Subject: RE: Delta Ignition Switch Voltage Drop follow up conference

PROPOSED PCB LAYOUT

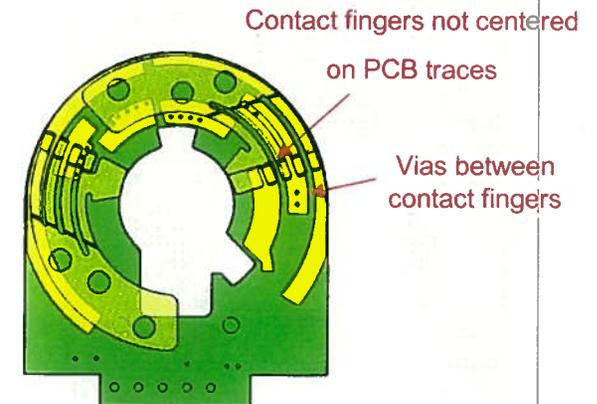
- Switch presents Contact Bounces & contact permanent deformation
- Customer rejects switches. Functional Problem when car starts

- Change PCB design to remove via holes from contact traces.
- Enlarge PCB vias to avoid contactors being in via limits.
- Detent plunger to increase torque force to be within spec.

- 1.-Validation for Torque & Angle for timing corrections ~ DONE
- 2.-GM RDE approve GM3660 ~ DONE
- 3.- Run 350 Switches for PTR in Mechatronics ~ DONE
- 4.- PTR samples approval with customer and tiers ~ 6/15/06
- 5.- **Mechatronics receive material for production ~ 6/26/06**
- 6.-SOP @ Condura for new PCB & Spring/Plunger ~ 6/30/06
